Title: Advisory Committee on Reactor Safeguards
Westinghouse AP1000 Subcommittee
Open Session

Date: Thursday, April 22, 2010

SUBCOMMITTEE ON THE WESTINGHOUSE AP1000 DCD AND

OPEN SESSION

Purpose

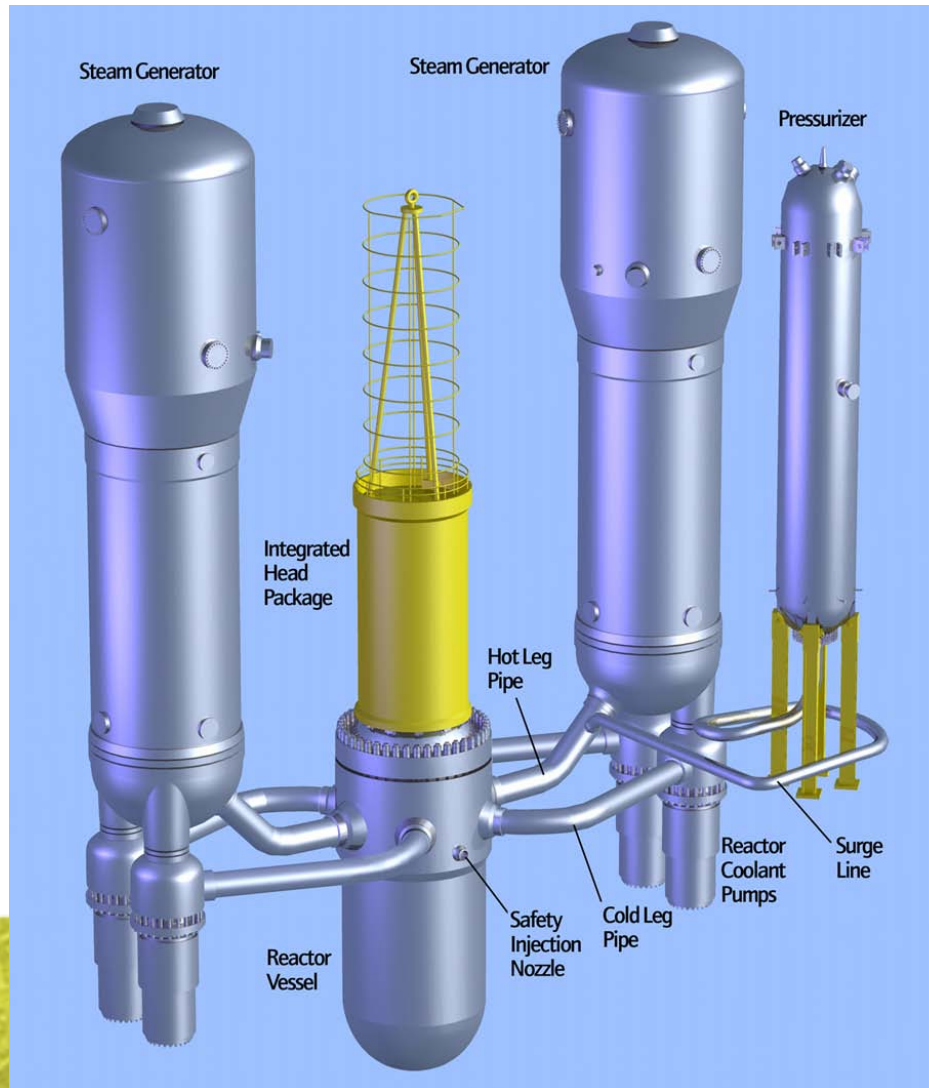
4 I wasn't there for the meeting, but the
5 gist of it was the questions about the use of elbow
6 taps for flow measurements, some information on
7 uniformity of flow to provide some additional
8 background how we'll monitor RCS flow measurements for
9 the system and the alternative methods that we've
10 proposed then are going to use both hot leg and cold
11 leg flow taps that we have.

10 MEMBER BANERJEE: Well the issue is this,
11 that the pressure drop or pressure change across the
12 elbow is related in some complicated way to the flow
13 rate, let's say volumetric flow rate.

- Baseline RCS Measurement of RCS flow at the time of plant startup utilizing multiple sources
- Use that flow determination for in-situ calibration of the RCS flow elements
 - Hot leg elbows and cold leg bends
- Use those flow elements for all further RCS flow measurements

Lines with Potential for Turbulence/Swirl Penetration

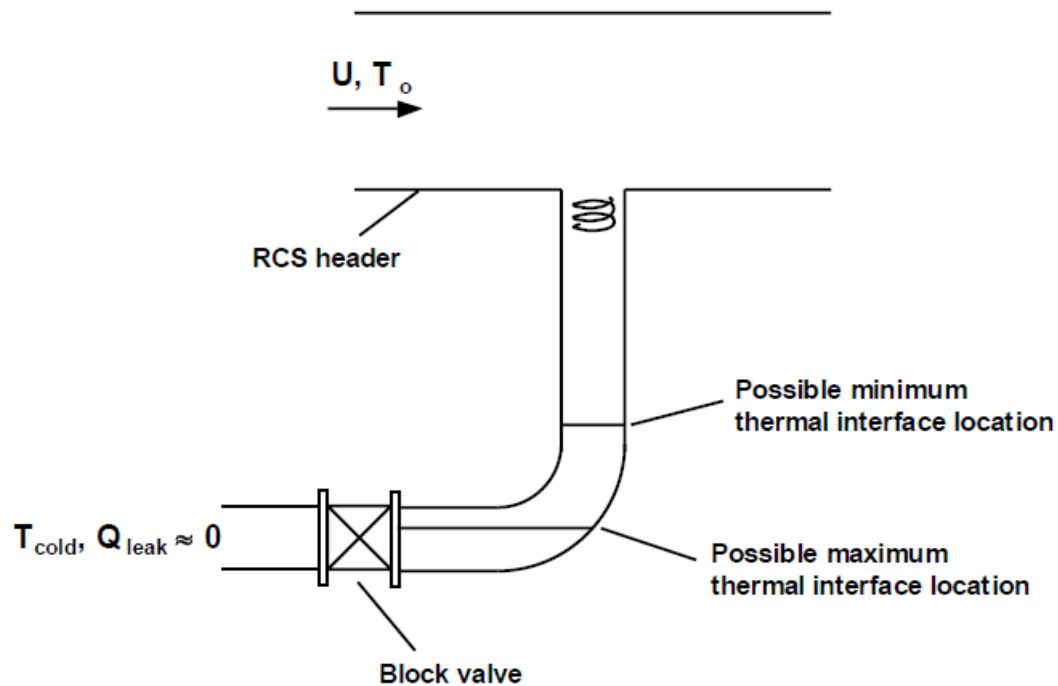
14 MEMBER BANERJEE: When I ask the question
15 I remembered from tests that were done in France back
16 in the maybe 20, 25 years ago which showed this
17 closed-end pipes that they were very serious effects
18 due to the vortices going in and out and creating
19 thermal striping.

3 MR. KOTWICKI: Yes. And that's the kind
4 of thing we would look at, you know, as part of a
5 fatigue analysis. And what we've done -- and we've
6 already gone through at least the screening aspect of
7 this in the AP 1000 plant.

19 If that's bad enough, then we'll take the
20 next step of doing, you know, incorporate a fatigue
21 analysis. The MRP-146 says, you know, depending on
22 where you are with all of these types of inputs, do I
23 do more inspection, should I monitor this line, should
24 I change the layout it's so bad, do I get a UC factor
25 that says this is horrible you better do something
